## Comments on Energy Star Program Requirements for Integral Lamps-Draft 3

Example of Highly **Non**-Omnidirectional Light Distribution That Passes as  
“Omnidirectional” under the DOE’s Draft 3 Standard

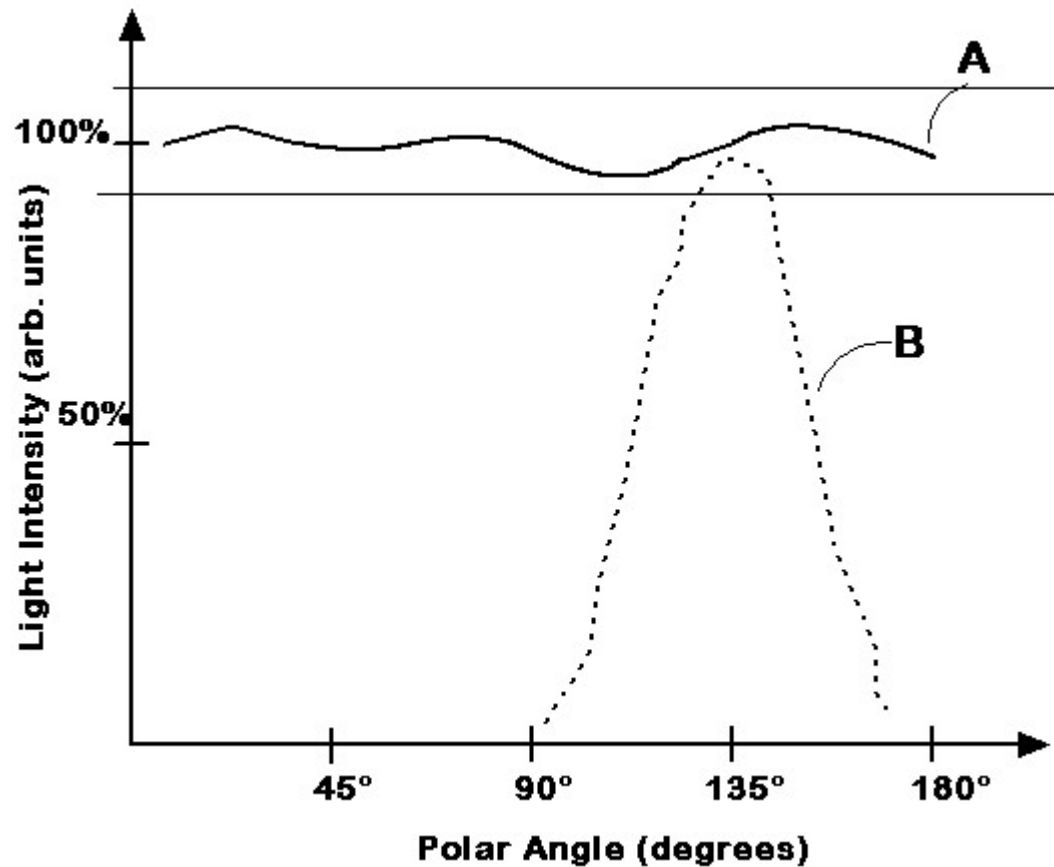
As a result, the only real requirement is B, and this is an extremely loose standard that allows for lamps with all kinds of wildly uncontrolled light distributions to qualify as omnidirectional. No light is required in 0° to 60° or for that matter in 0° to 90°.

The graph above shows plots (A & B) of light intensity versus polar angle for the light emitted by LED light bulbs. Plot A is for a good omnidirectional lamp. The lamp represented by plot A emits light fairly evenly from 0° to 180° (in all directions=omnidirectionally). The lamp represented by plot B does **not** provide omnidirectional illumination. The illumination of B is limited to the polar angle range from 90° to 180°. The illumination of B is also very uneven (non-uniform). It is strongly peaked at 135°. Yet contrary to reason, the plot B distribution qualifies as “omnidirectional” under the DOE’s draft-3 *Energy Star* requirements.

1200  
*Fig. 13*

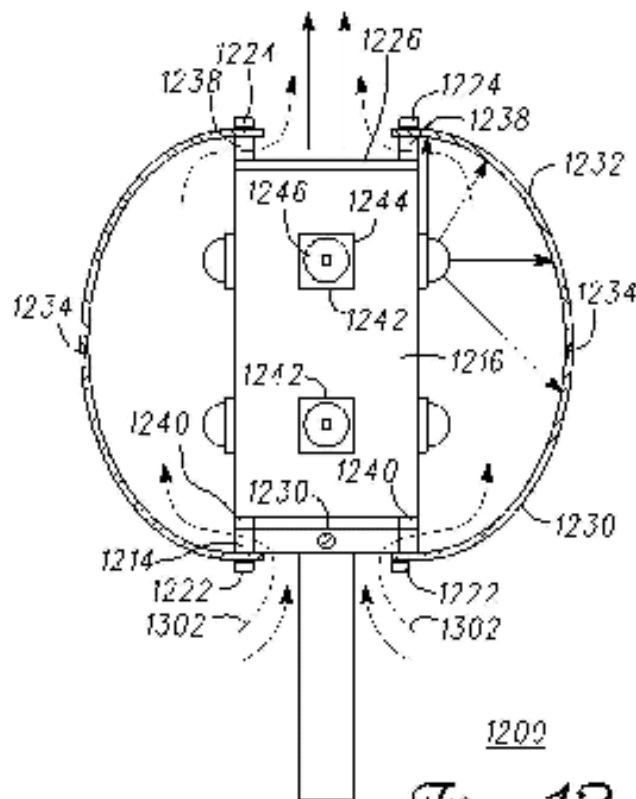
FIG. 13 is partial cross-sectional view through the top of the bulb which illustrates an arrangement of the outer bulb shape diffuser that allows all the light emitted by the LEDs 1244, 1242 to be diffused by the diffuser while allowing natural convection air flows to flow through and around the central heat sink. The overall thermal resistance of the bulb is much better than existing LED bulbs and can handle 10 watts of LED input power while maintaining the LEDs well within manufacture recommended temperature limits.

*Fig. 23*

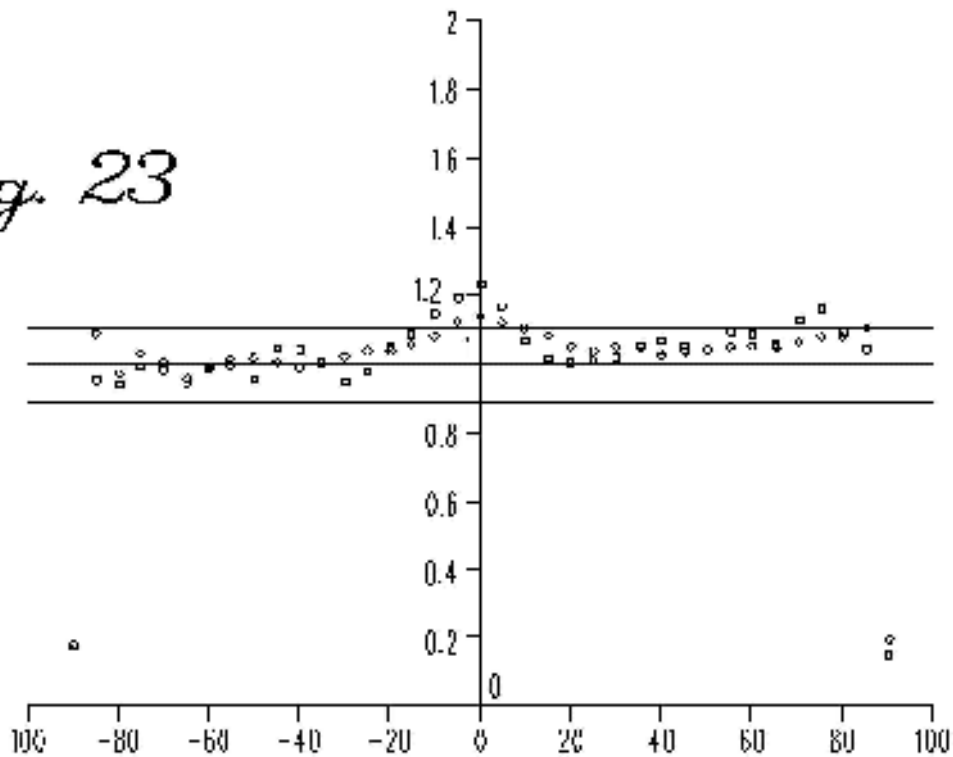
By providing the LEDs with specially designed (patent pending<sup>13</sup>) lenses, each LED can be made to emit nearly uniformly over a hemisphere ( $2\pi$  Steradian). The near uniformity is shown in the graph below with intensity represented by diamond symbol data points plotted against polar angle. (It is expected that even more uniform lens could be produced with a couple of design iterations made on higher precision equipment than was available, BUT these lenses are sufficient, when used with a diffusive bulb-shaped cover 1232, 1230, to meet the more stringent standard proposed herein.)

FIG. 4.

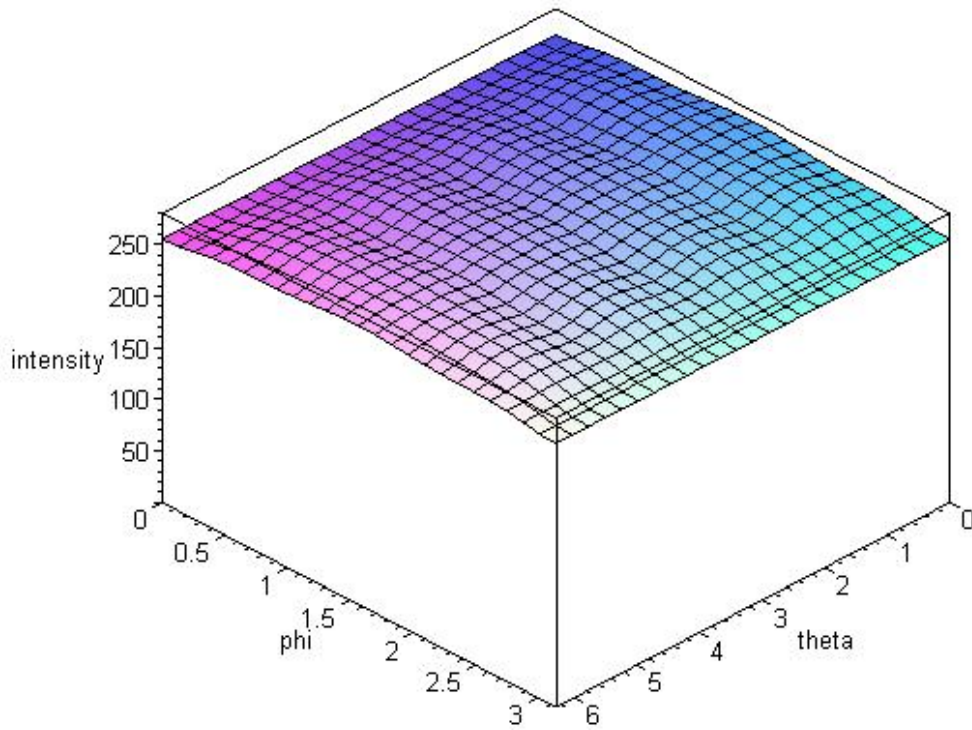
By arranging the LEDs in the bulb facing in all four cardinal directions, each pair of LEDs facing in opposite directions (e.g., N & S) will nearly cover the complete sphere of solid angle,  $4\pi$  steradian, around the bulb. The two pairs together (e.g., N & S and E & W) will cover the  $4\pi$  steradian twice over. Light from different LEDs combines together generally smoothing out the small ripples in light intensity shown in FIG. 23. The bulb shaped diffusive cover (250, 1230, 1232 in FIGs. 3, 13) further smoothes the ripples in intensity. The resulting light distribution over  $4\pi$  Steradian is quite uniform as shown in FIG. 4 below. The maximum intensity is 8% higher than the minimum so that the originally proposed (Draft-1) uniformity specification of  $\pm 10\%$  relative to the mean can easily be met and the same standard can be met over the wider proposed 0-180° range.
